Final response to RC2

Review of The impact of small-scale surface representation in WRF on hydrological modeling in a glaciated catchment by Hofmeister et al., submitted to HESS.

Figure 1. Mean WRF temperature lapse rates in $^{\circ}$ C /100 m for two pairs of consecutive eta levels and averaged over the Kauner Valley. The red line represents the mean lapse rate between eta levels 1 and 20.

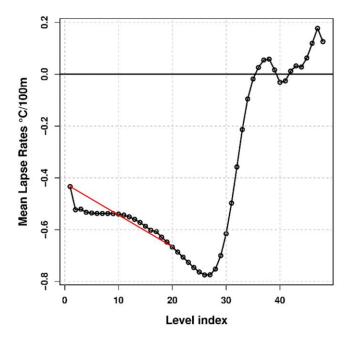
1. The manuscript is long and overly descriptive in places in order to present a methodological step toward improving forcing for a hydrological model. However, a complete analysis of why and where the hydrological model is improved using the lapsed free-air WRF temperatures is still lacking in places. There is no testing of alternate lapse rate approaches or using different pressure level combinations from the WRF, nor whether 'ignoring' the WRF near-surface temperature attribution due to landcover type is in any way dependent upon certain conditions or times of year. The transition to a technical note for the journal should see shortening of other sections describing the WRF and WaSIM modelling, where appropriate, especially where details can be provided in summary tables (main text or SI).

Fig3: The exact derivation of the pressure level lapse rate for this figure is unclear. Is this the regression of temperature and elevation for each level, as shown by Fig 2? This approach is however different to how the authors derive lapse rates applied to WaSim, however (by averaging temperatures for each level). What about taking the lapse rate in a similar way to what we see in Fig 3, from the nearest WRF pixel? This would implicitly account for the often shallower lapse rates observed over glaciers. Regarding this figure, the distinction to the methodological approach of the text should be given and explained. Ideally, the authors can also add the approximate elevation from the eta levels for interpretability, marking the elevation range of the catchment on top.

Our assumption is that the sensitivity of temperature lapse rates depends significantly on the first eta level (~17 m above ground), as there is a much more homogeneous transition at the subsequent levels, as shown in Figure 1 (Fig. 3 in the manuscript). We can calculate the different lapse rates based on different combinations of eta levels and add them to the Supplement.

The calculation of the lapse rates shown in Figure 1 (Fig. 3 in the manuscript) is based on two pairs of consecutive eta levels (e.g., 1 and 2). Accordingly, it is the mean lapse rate of two consecutive eta levels and of all grid cells in the Kauner Valley. Except for the lapse rate between the first two eta levels, all the others up to level 20 range between -0.52 and -0.67°C/100 m. We will add this information to the manuscript.

As mentioned above, the calculation of the lapse rates shown in Figure 1 (Fig. 3 in the manuscript) is based on two pairs of consecutive eta levels (e.g., 1 and 2). Accordingly, it is the mean lapse rate of two consecutive eta levels and of all grid cells in the Kauner Valley. We will add this information to the manuscript. This figure is intended to illustrate the sensitivity of the temperature lapse rate to the eta levels. We will highlight the elevation range of the research area in Figure 3 of the manuscript.

Figure 2. Flowchart to illustrate the various steps for computing the corrected WRF temperature from eta level 1 and 20.

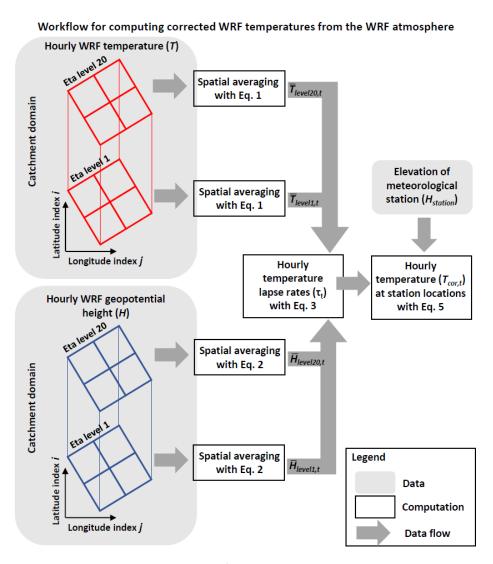
2. Regarding the methodological details for the derivation of the lapse rates from pressure levels of WRF, the details are actually lacking still, and it's not clear to me exactly how or why the lapse rates have been derived the way they have. For example, from my reading, the authors average temperatures (and geopotential heights) for each level for each time step (equation 1+2), but then use only a linear fit for the 20th and 1st levels (equation 3), and then make an average of all hours (equation 4). The authors

make the claim that the spatial averaging on each level makes the lapse rates more robust, though with no real evidence of this. This may be negligible due to the size of the catchment, but the reader has no way to understand if the land surface variations (in this case, most of the glacier cells are to the south of the catchment) could still have some impact on the lapse rates and comparison to the observations and impact on the hydrological model etc. The information in figure 3 also highlights that lapse rates are calculated for each elevation band, but it is unclear how that was derived (stepwise lapse rates?), whether taking different eta levels or removing the lowest level (which retains the impact of surface exchanges of WRF) impacts the results of the study here, and potentially for other applications. The authors need to make a clearer case to justify what lapse rates they apply, how robust their approach actually is, and how their approach might succeed or struggle in other, potentially larger, domains. The true value for the community is therefore minimal at the current time.

We will strive to provide a clearer explanation of how we performed the calculation and the reasoning behind it. We first perform spatial averaging for temperature (Eq. 1) and geopotential height (Eq. 2) at each eta level. The actual lapse rates between eta level 1 and 20 are computed with Eq. 3. The temporal averaging in Eq. 4 is only considered in the evaluation of mean lapse rates over longer periods (e.g., for 1970-2015). These temporal averages are not considered in the hydrological modeling, as the model assimilates the corrected and uncorrected hourly temperatures. The uncorrected WRF temperature provides the elevation of the WRF grid cells to the hydrological model, whereas the corrected WRF temperature already represents the actual station elevations computed with Eq. 5.

We generated a flowchart to illustrate the processing of the corrected WRF temperature from the different Eta levels. We hope that the flowchart improves the comprehensibility of this section. Since the current order of Eq. 4 and Eq. 5 is a bit confusing, as it suggests that Eq. 4 is used to calculate the hourly lapse rates, we will swap these two equations in the manuscript.
